Serial Nr.: 10/717,258

AMENDMENTS TO THE DRAWINGS:

<u>REMARKS</u>

FIG. 1
(PRZOR ART)

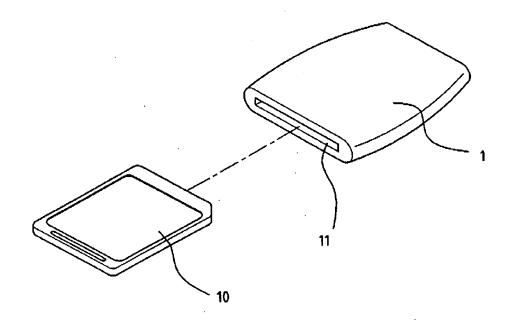
FIG. 1 is amended to include a legend --Prior Art-- as shown in the attached annotated sheet of the drawing.
